HORSHAM DISTRICT COUNCIL CONSULTATION

TO:	Horsham District Council – Planning Dept
LOCATION:	Land East of 1 To 25 Hayes Lane Slinfold
DESCRIPTION:	Outline application with all matters to be reserved except for access and layout, for the erection of 38no. dwellings, (including 13no. on-site affordable housing units), together with access from Hayes Lane, vehicle and cycle parking, landscaping, open space and play provision, sustainable drainage, and re-alignment of Public Right of Way No.3782
REFERENCE:	DC/25/2006
RECOMMENDATION:	Advice / modification to roadside TPO'd trees RPA's and modification to new western road alignment is needed to address its location in the RPA of trees T60 and T61; Holding objection is currently raised to the scheme on the above grounds
2nd response in Red	Advice / modification / Holding objection – not supported on arboricultural grounds; objection maintained on the grounds of unjustified development within the RPA of trees T60 and T62. Please seek amendments to the drainage layout and the proposed western road alignment where these encroach into the RPAs of the TPO trees.

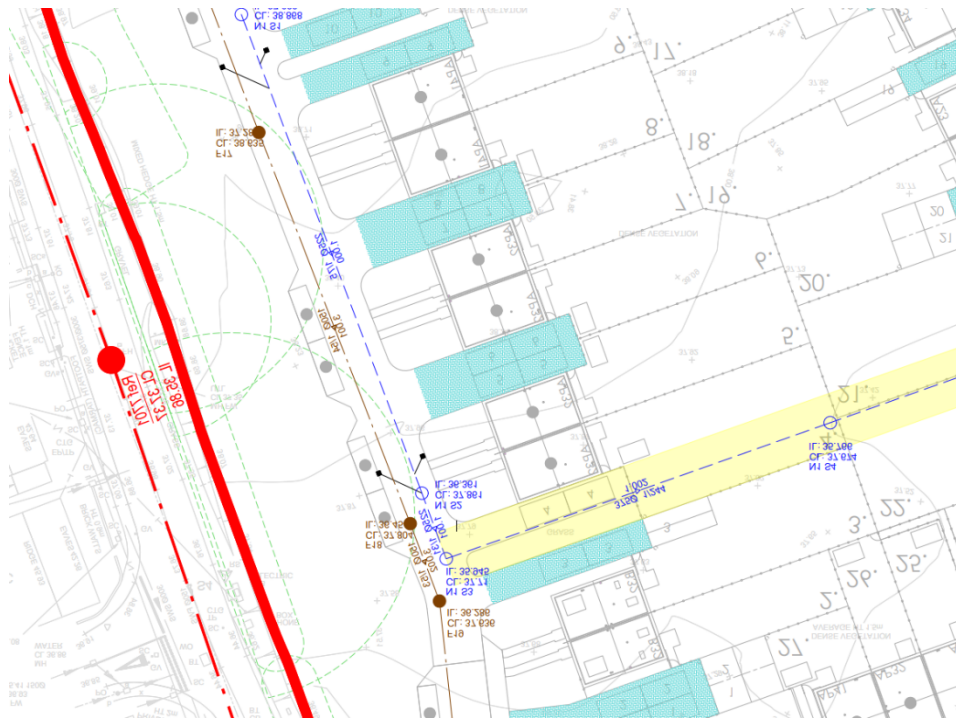
While the amendments to the RPAs of Trees T60 and T62 are welcomed, it is now apparent that sections of the service road will be located within the RPAs of both trees to a greater extent than was originally shown. In this respect, it is noted that BS 5837:2012 advises at Paragraph 5.3.1:

However, while the AIA and Tree Protection Plan (TPP) have provided a technical solution in the form of an above-ground construction method for those sections of road situated within the RPAs of T60 and T62, I have been unable to identify any reference to the overriding justification that has been provided to support this aspect of the scheme.

As previously noted, given the greenfield nature of the site, where the layout could readily be adapted to avoid any incursion into the RPAs of these trees, I do not consider there to be any overriding justification for this element of the proposal. Consequently, I am unable to support this aspect of the scheme in its current form.

Although the RPA incursion would fall below the maximum 20% threshold advised within BS 5837, in this case any incursion is easily avoidable. As mentioned previously, the rear gardens of the units located directly opposite the subject trees, together with those on the opposite side of the site, are approximately 28 m in length and could be shortened to allow the road alignment to be moved further east. This would avoid any encroachment into the RPAs of the trees altogether. Given the availability of a straightforward design solution which would remove the need for development within the RPAs, I do not consider the proposed incursion to be justified.

In addition, concerns are raised regarding the proposed drainage infrastructure within the Root Protection Areas (RPAs) of T60 and T62. Given the foreseeable impact on these TPO-protected trees through potentially harmful root severance associated with the installation of the drainage infrastructure, this further supports the need to shorten the gardens of the adjacent units and reposition the road alignment and drainage infrastructure outside

of the trees' RPAs. Please see the amended layout below, which seeks to address these concerns.

A simple solution to the above points regarding trees T60, T61 and T62, would be to reduce the size of the generously sized rear gardens of the some of the units on the western side of the site. This would allow for the parking bays and road alignment to be modified around the amend RPAs of trees T60, T61 and T62. Which would likely address the above concerns and proved a more sympathetic tree conscious form of development.
